TECHNICAL BULLETIN		Mfg: FORD
	March 2000 TB 1781	Model: TAURUS
		Liter: 3.0L
		V I N: S
		Year: 96-06

Revised Camshaft Timing Procedure For
1996-99 Ford 2.5 & 3.0L VIN L & S Engines

Bulletin Diagram: TB 1781 Figure 2 - CAM TIMING

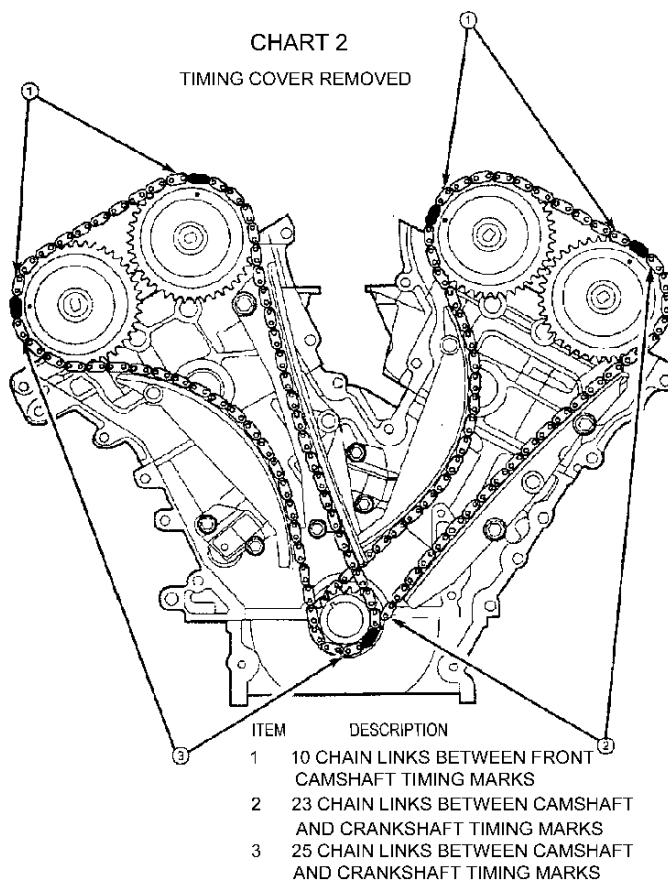
This revised method of timing is advised as previous marks on the rear of the cam sprockets may be mis-marked by as much as 30° of rotation. Previously published (pre 2000) service information should not be referenced for timing procedures. The revised method uses the front cam sprocket marks in a more conventional method of timing.

Front Timing Cover Removed:

1. Rotate the engine clockwise until the front camshaft sprocket marks are toward their top side and the crankshaft keyway is at the 11 o'clock position (TDC).
2. To verify correct timing, count the number of chain links between front cam sprocket timing marks and the crankshaft sprocket timing marks. The cams are correctly timed if they match the data in Chart 2

Bulletin Diagram: TB 1781 Figure 1 - CAM TIMING

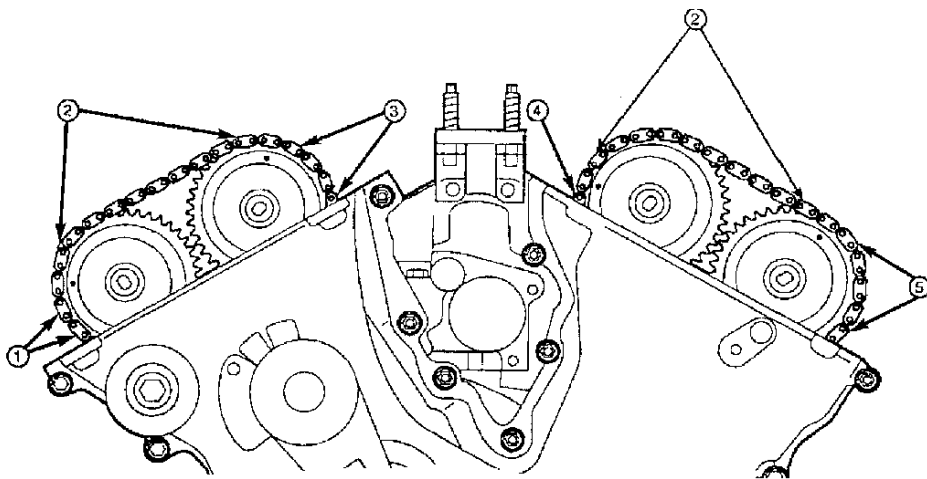
Front Timing Cover Installed:

1. Rotate the engine clockwise until the front camshaft sprocket marks are above the timing cover top edge and the crankshaft damper notch is aligned with TDC pointer.
2. To verify correct timing, count the number of chain links between the cam sprocket timing marks and the timing cover top edge. The cams are correctly timed if they match the data in Chart 1.

ITEM	DESCRIPTION
1	2 CHAIN LINKS BETWEEN FRONT COVER AND FRONT CAMSHAFT TIMING MARK
2	10 LINKS BETWEEN FRONT CAMSHAFT TIMING MARKS
3	3 & 1/2 LINKS BETWEEN FRONT COVER SURFACE AND FRONT CAMSHAFT TIMING MARK
4	1/2 CHAIN LINK BETWEEN FRONT COVER SURFACE AND FRONT CAMSHAFT TIMING MARK
5	5 CHAIN LINKS BETWEEN FRONT COVER SURFACE AND FRONT CAMSHAFT TIMING MARK
